# **Whale Tail 2023 Annual Open Pit Geomechanical Inspection**

## **RE: Meadowbank Complex - Amaruq Site - 2023 Annual Open Pit Geomechanical Inspection**

### **Meadowbank Complex - Amaruq Site - 2023 Annual Open Pit Geomechanical Inspection**

## Observations - Northwest Wall - Backbreak (Cont'd)

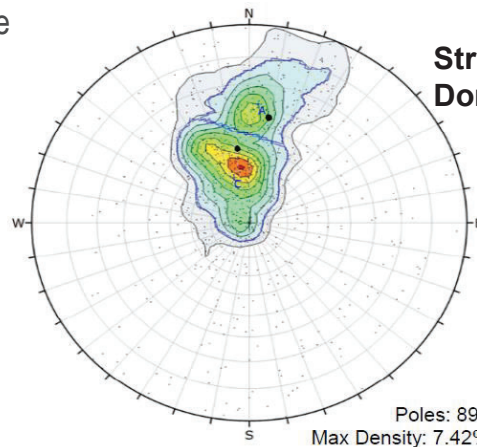
- The majority of the wall is performing well, particularly given that it is entirely established within the Komatiite. Half barrels are often visible and the design geometry appears to have been achieved (though this has not been verified).

- There are intervals with poor bench performance (example at far right in the image below). These areas appear to be associated with Brittle / High Strain Structures, persistent discontinuities dipping at a shallow angle to the south (S3 foliation?), and wedges formed by these structures and Joint Set D.

- The western end of the wall, near the ramp, is of notably lower rock mass quality. A prominent structure defines the eastern limit of this zone (yellow dashed line below). The reduction in rock mass quality is believed to be due to the presence of multiple Brittle / High Strain Structures (see next slide). The foliation in this area is distorted and at least locally has a much shallower dip (white dashed lines below, possibly the S3 foliation).

**Structural Domain 1K**

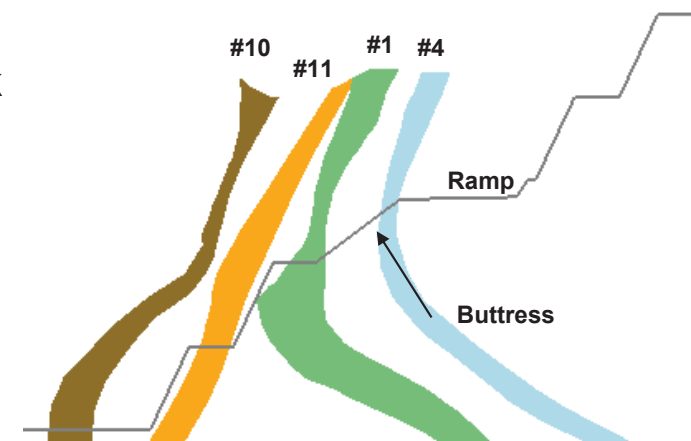
- Brittle / High Strain Structures 1, 4, 10 and 11 are all predicted to intersect the wall in the area where the excessive overbreak occurred below the ramp. Structures 1 and 4 are categorized as “Major Zones” by AEM, with greater confidence in their interpretation.

- Structure 4 agrees well with survey measurements of the structure that defines the northern limit of the zone of sheared Komatiite noted on the previous slide (yellow dashed line). This zone also includes Structures 1 and 11 and lies on the contact between the Iron Formation and Komatiite.

- The Brittle / High Strain Structures are often associated with a significant reduction in rock mass quality within the Komatiite. This is likely a key driver for the overbreak that occurred adjacent the ramp.

- The orientation of the foliation was mapped in several places along the wall and compared to Structural Domain 1K. The measurements taken further to the east generally agree with Joint Set A (S1/2 Foliation) while the failure planes below the ramp (white dashed lines on previous slide) are much closer to the S3 foliation. It is not clear if this is the S3 foliation or a local rotation in Joint Set A.

- The Brittle / High Strain Structures should be mapped to validate/refine the structural model.
- Structural mapping should be completed to better understand the variation in the foliation.

- If there are significant changes in the understanding of the rock mass structure, the potential impact on the slope performance and design should be reviewed.

## Observations - Phase 1

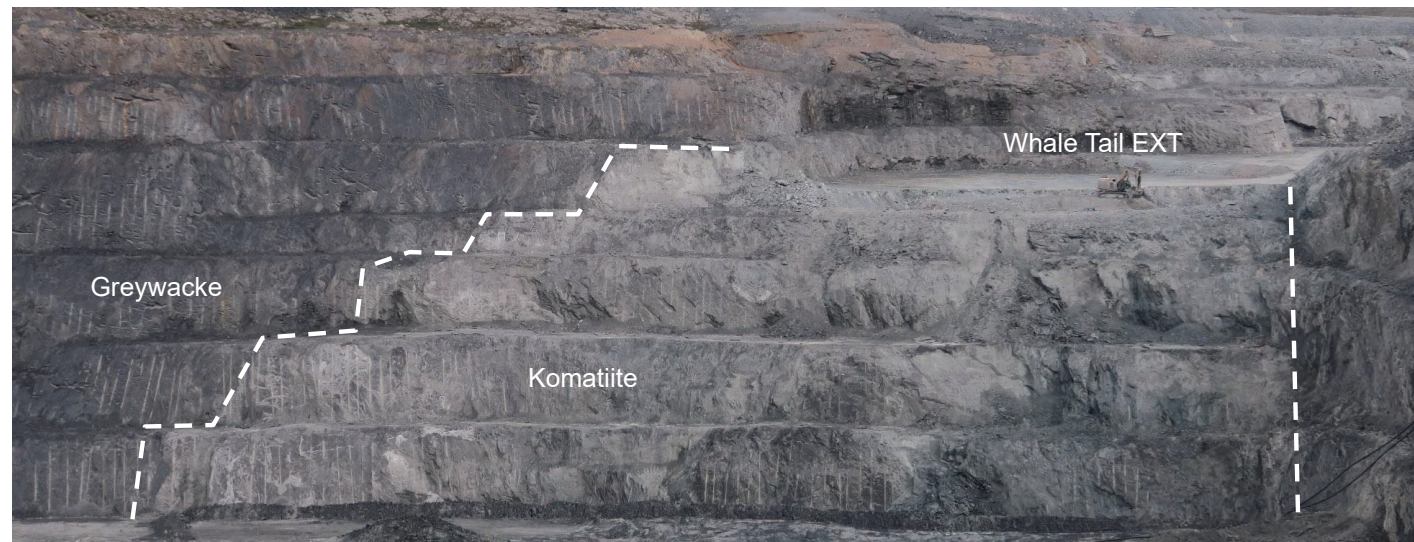
- Mining of Phase 1 was completed in the first half of 2023. The ramp to Phase 1 is currently bermed off.
- The North Wall wall was established in the Komatiite, parallel to the foliation and experienced a series of bench-scale planar failures. Mining along the North Wall was successfully prioritized during winter to minimize the rockfall risk to personnel. A berm was installed at the toe of the slope prior to freshet to retain the expected rockfall. This approach was successful.

- A multi-bench instability occurred on the North Wall on May 14, 2022. As the first multi-bench failure to occur at Amaruq, it is important that this failure be back-analyzed to understand the failure mechanism. This has not yet been done.

- It is understood that access may be re-established to Phase 1 for dewatering purposes. The risks associated with on-going access below the failure, as well as the rockfall hazard associated with on-going mining of Phase 3 should be reviewed and mitigation measures implemented as appropriate.

## Observations - Northeast Wall (Cont'd)

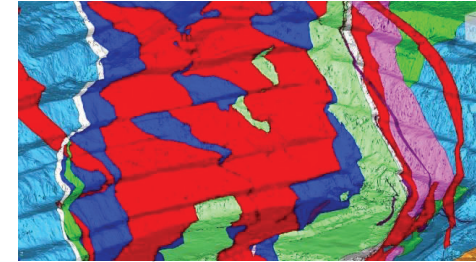
- Two “Major” High-Strain / Brittle Structures intersect this wall (BS1 and BS5). These structures have strongly influenced the slope performance and contributed to many of the bench-scale failures to date. Jonathan Servais (3D Modelling Geologist) of AEM has high confidence in the interpretation of both structures.

- BS5 has had a greater adverse effect on the slope performance than BS1. BS5 is associated with a small Iron Formation lens linked to the Mineralized Zone # 92. The mechanical contrast between the Komatiite and the Iron Formation could explain why BS5 is more prominent.

- The position of BS5 on the wall is expected to move closer to the NE corner of the pit as mining progresses to depth. This is generally favourable. Outside of BS1 / BS5, the Komatiite is more competent and half-barrels are sometimes visible. Minor shears and the foliation often locally define the bench face.

- A notable exception is the Komatiite along the western contact with the Greywacke. The Komatiite in this area is quartz-rich and numerous veins and veinlets are present. The bench faces locally stand steeper than the foliation after thawing. Matt Dewar (Geologist) of AEM noted that this quartz-rich zone is the IC Zone (Mineralized Zones #51 and 52). This zone pinches out towards the west and is not expected to be present in the Northwest Wall of the open pit.

- Assessments of the overall stability of this wall have assumed a weak structure along the western contact. The presence of the IC Zone suggests that this assumption is conservative.

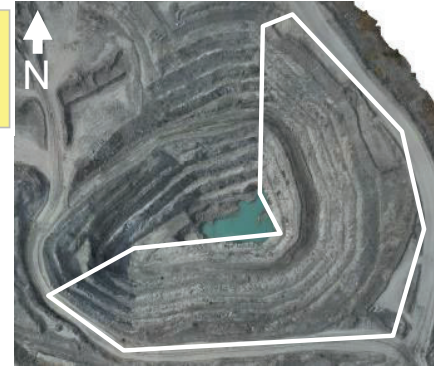
- As a result, the mine trialled a 55° pre-shear and then a 65° pre-shear to define the bench face. The 55° pre-shear trial was successful, but a series of bench scale planar and wedge failures have occurred in areas where the 65° pre-shear was trialled, including four in September 2022. The areas are outlined below.

- The failures outlined in yellow occurred on September 3 and 8, 2022 and were not anticipated. They were investigated as near misses. As a result of these failures, the mine implemented radar monitoring of this wall, reverted to a 55° pre-shear, and prioritized the completion of the V1 pit before the 2023 freshet.

- It is understood that overspill from the V2 open pit was successfully managed, and that very little material reached the ramp during blasts.

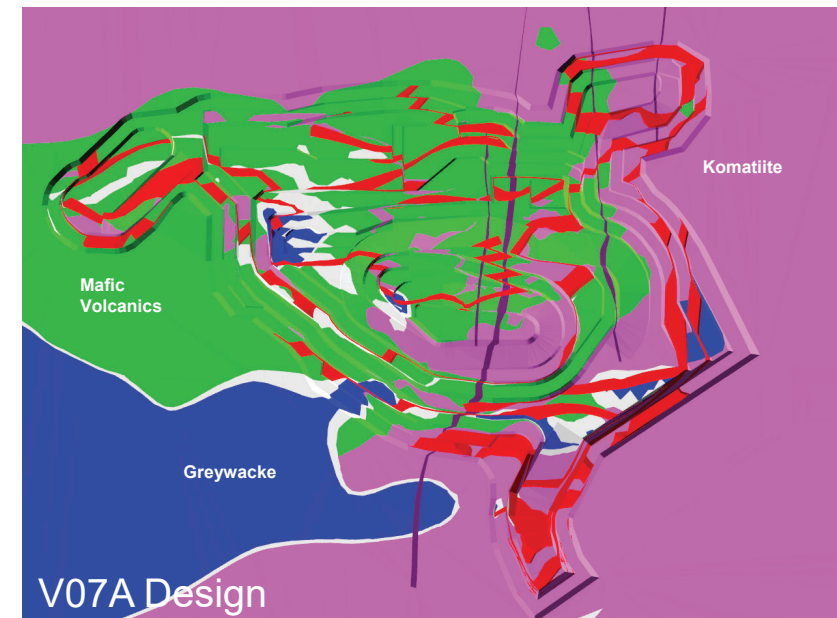
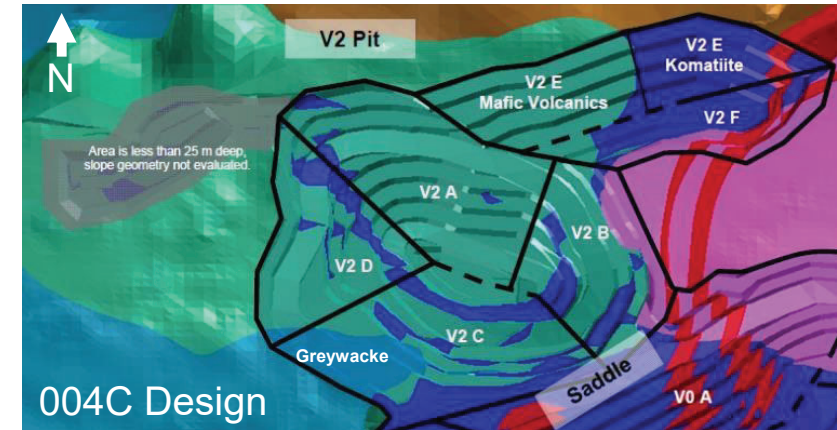
- The rock mass structure and quality is favourable in this sector and have not limited the achievable bench geometry.
- However, Drilling and Blasting practices are having a strong influence on bench performance, with hard toes, crest loss, and frozen rock on the face observed regularly along this wall. Irregularly spaced half-barrels were observed in some areas. It is likely that the design catch bench width is not being consistently achieved. These practices are discussed in greater detail later in this presentation (Slide 60).

- The northern end of the wall (not shown in image below) was established below the former Lake A49 and the uppermost bench is characterized by a oxidized and blocky rock mass.

- The nose between the V1 and V2 open pits represents a potential rockfall hazard and should continue to a focus of the visual inspections.

## Review of IVR V2 Open Pit Design (Cont'd)

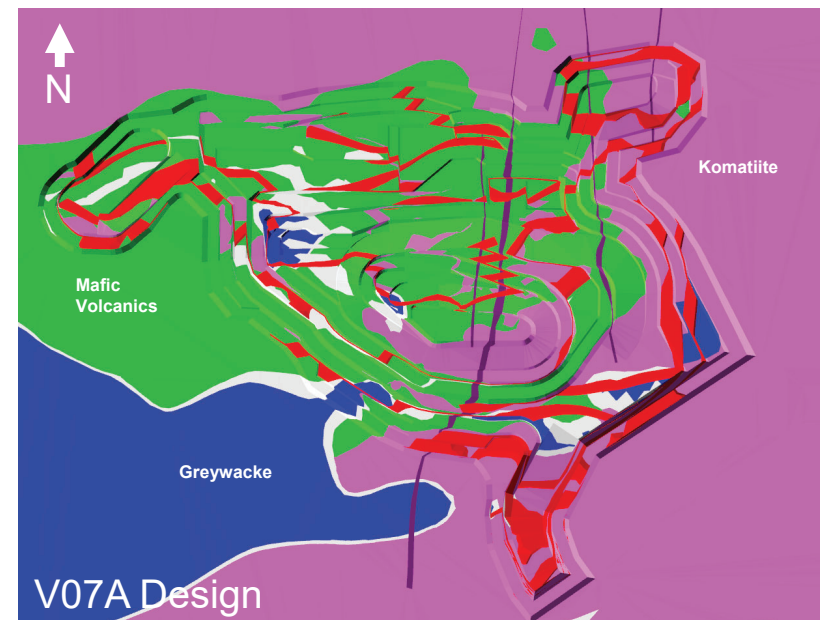
- The North Wall of the V2 open pit was designed to be within the Mafic Volcanics rather than the Komatiite in order to reduce the potential for bench- and inter-ramp scale planar failures on the foliation. If the wall is established in the Komatiite, a shallower slope would be required.
- The North Wall of the V07A design is still predicted to be within the Mafic Volcanics. However, Geology has noted that the lithological interpretation for IVR is complex and that the modelled lithologies do not necessarily agree with the drillhole data. The broad trends are still thought to be generally reliable. On-going geological mapping to verify that the North Wall is in fact being established in the Mafic Volcanics is recommended.

## Review of IVR V2 Open Pit Design (Cont'd)

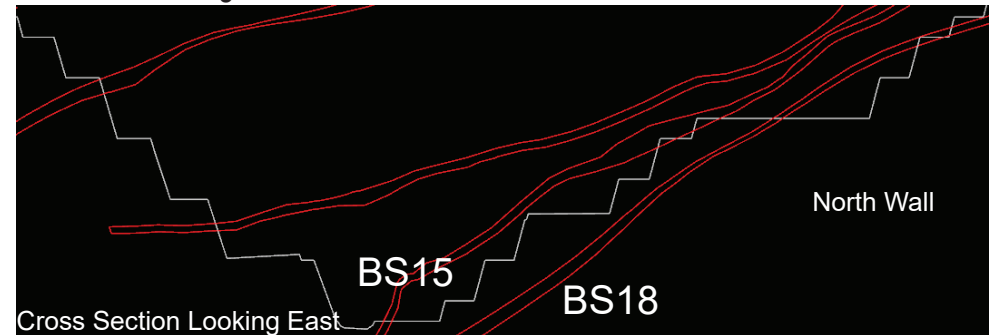
- The High-Strain / Brittle Structure model did not cover the North Wall of the V2 open pit at the time the open pit slope geometry recommendations were developed. The model has since been expanded and refined. Brittle Structure 18 is modelled immediately behind the wall and Brittle Structure 15 is modelled along/immediately inside the wall (see image below).

- As modelled, the orientation of the high-strain / brittle structures is much more consistent than that of the modelled lithology contacts. Jonathan Servais (AEM 3D Modelling Geologist) indicated that he has the least confidence in the structures modelled in the IVR V2 open pit. It is possible that thrust faults are present in IVR V2 and that the modelled folds are actually displacements/offsets in the structures along these thrust faults.

- The performance of the North Wall will be sensitive to the position, orientation and persistence of these structures. If the current structural model is correct, there is significant potential for an inter-ramp scale failure. If the modelled structures represents a series of structures, they are more likely to result in bench-scale failures. The uncertainty in the geological interpretation increases the geomechanical risk in this area.

## Hazard and Action Item Tracking

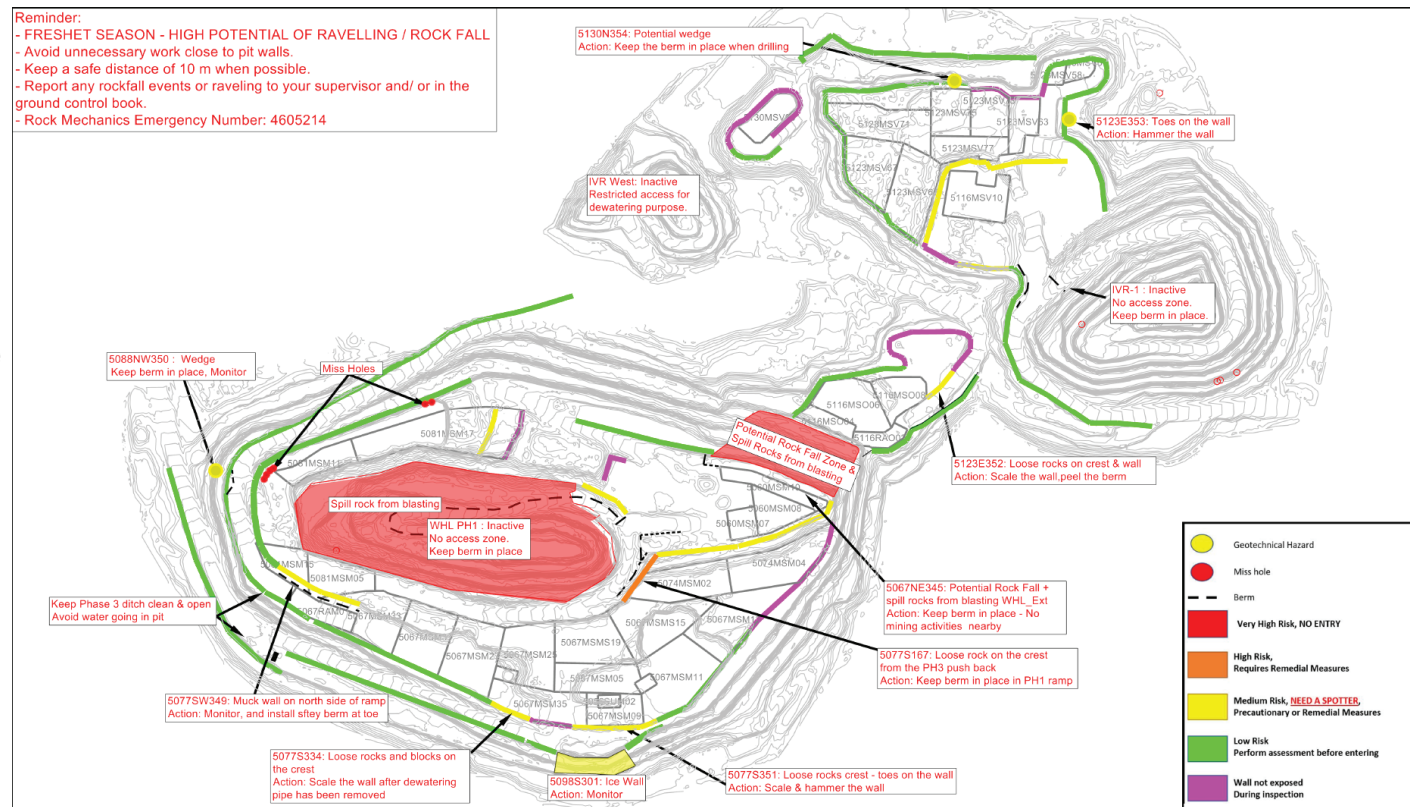
- Hazards, the associated risk rating, and any required corrective actions are tracked in a database. An example from the database is shown below.
- A total of 84 hazards were identified between July 2022 and July 2023. The most common hazards (70) are associated with rockfall hazards or loose. The remainder are typically associated with hard toes or icefall hazards.

- A due date to complete the corrective actions is specified. Often it is linked to an action rather than a date (e.g., “before drilling adjacent pattern”). Overdue items are not flagged. Recommend setting up a mechanism within the database to flag overdue corrective actions so that they aren’t overlooked.

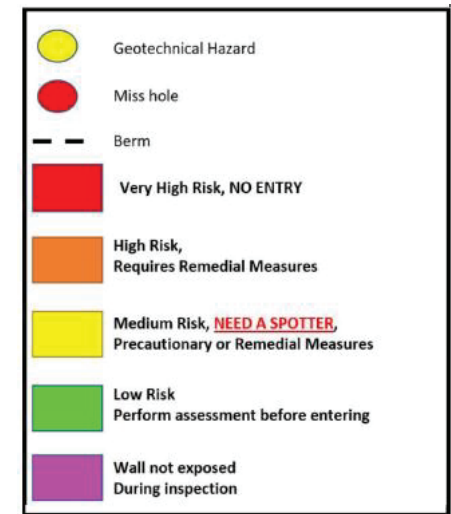
- The procedure was reviewed and updated in June 2023. The primary change is that the legend on the hazard map has been refined to note the requirement for a spotter when working within a Medium Risk area (Yellow Rating).

- The hazard maps now focuses on rock mechanics hazards. While corrective actions related to the identified hazards are noted on the map, the corrective actions are primarily communicated and tracked through the Pit Wall Approval procedure and the Hazard Tracking Database.

- There are multiple hazards documented in the Hazard Tracking Database that have been removed from the Hazard Maps as they are located in inactive areas. This addresses the short-term risk but there is currently no mechanism to ensure these hazards are revisited or mitigated before mining resumes or other access is required for other activities (e.g., dewatering).
